REGIONAL REVIEW NOTIFICATION

ARC REVIEW CODE: R1903051

Name of Proposal: McCamy Mixed-Use Development (P & L Big Shanty Road)

MCCAMY MIXED-USE DRI #2860
Cobb County
ARC Natural Resources Group Comments
January 28, 2019

DRI NUMBER: 2860

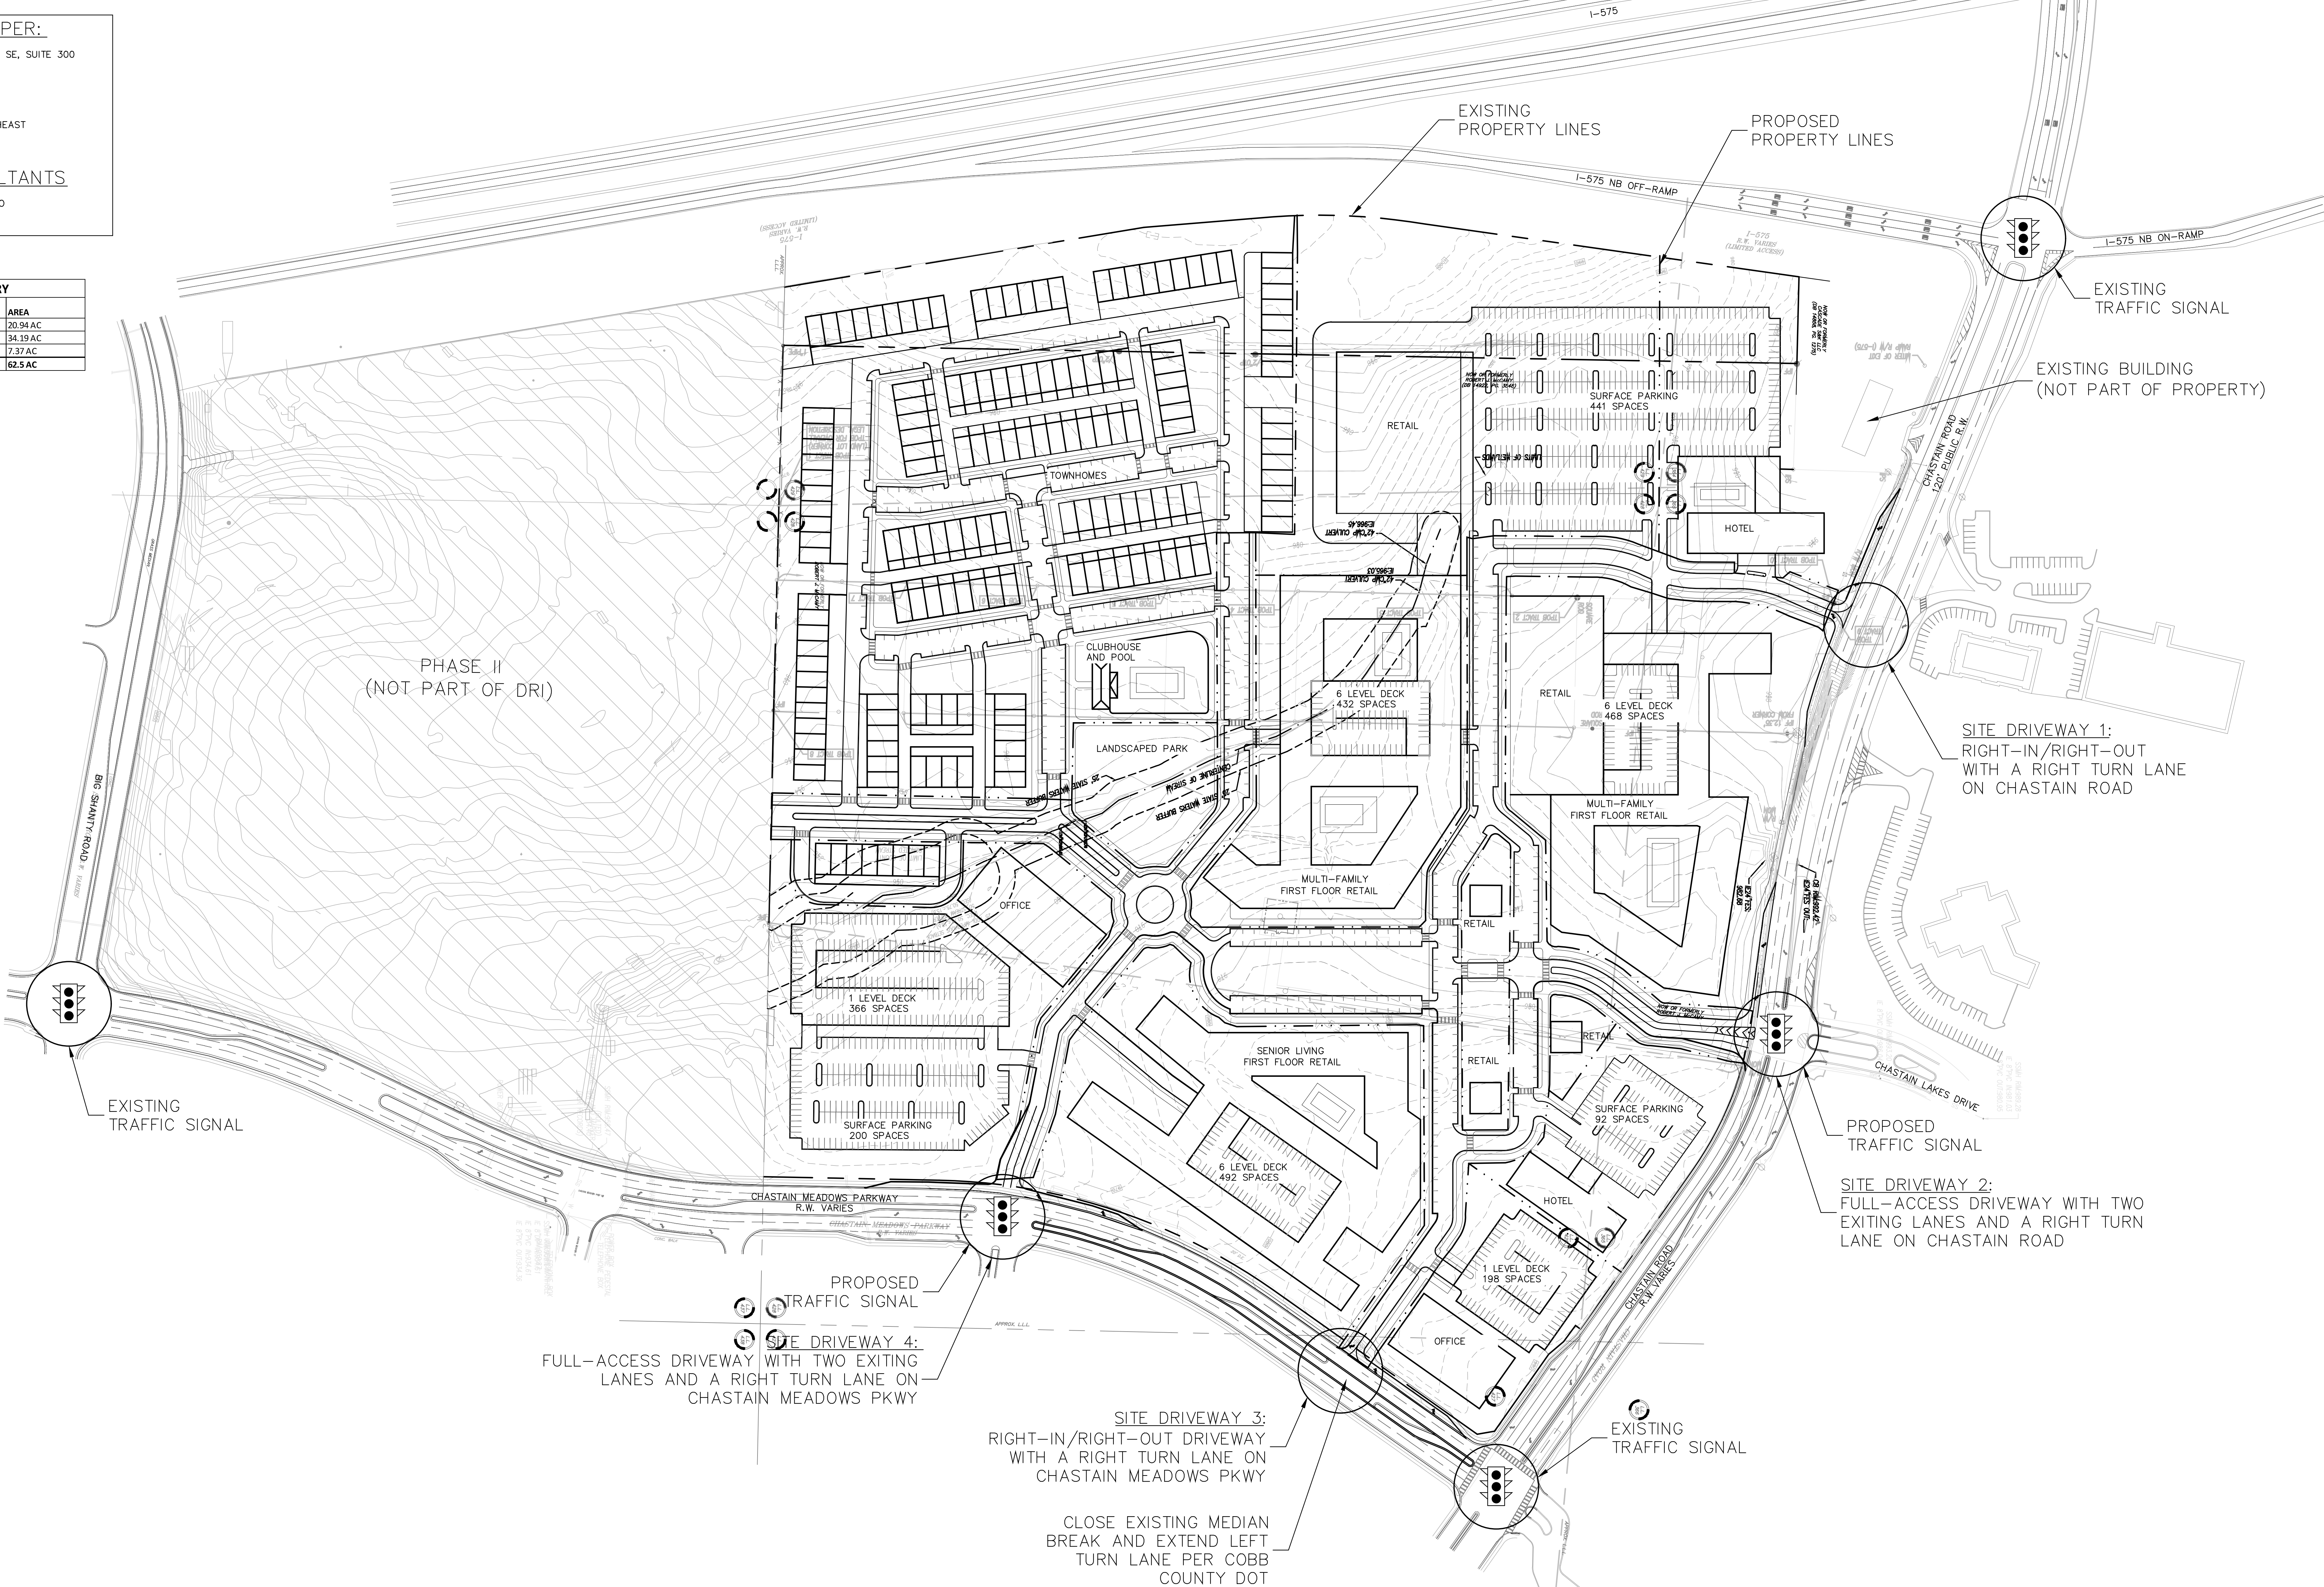
The USGS coverage for the project area shows no blue-line streams on the project property, but the project site plan shows a stream starting near the center of the property and then running south to the project property line. The State 25-foot sediment and erosion buffer is shown for most of the stream length. The buffer area widens out to an approximately 50-foot/75-foot buffer in about the last 400 feet before the property line. The 25-foot State buffer is not shown in this area, and the wider buffers are not identified, but they may indicate the County stream buffers. Much of the stream will be covered by parking, roads and buildings, and the plans show a section that will be culverted. Intrusions into the County buffers may require a variance. Any intrusions into the State sediment and erosion buffer will also require variances. Any unmapped streams on the property may also be subject to the State 25-foot buffer and Cobb County Stream Buffer Ordinance. Any unmapped waters of the State on the property will be subject to the requirements of the State 25-foot sediment and erosion buffer.

Site plan does depict internal sidewalks. The traffic analysis does not indicate whether bicycle facilities will be constructed internally. Pedestrian and bike facilities currently exist along Chastain Road.

The site plan does not provide specific information or depictions of bicycle and pedestrian facilities, however existing bike ped facilities provide connectivity to adjacent parcels.
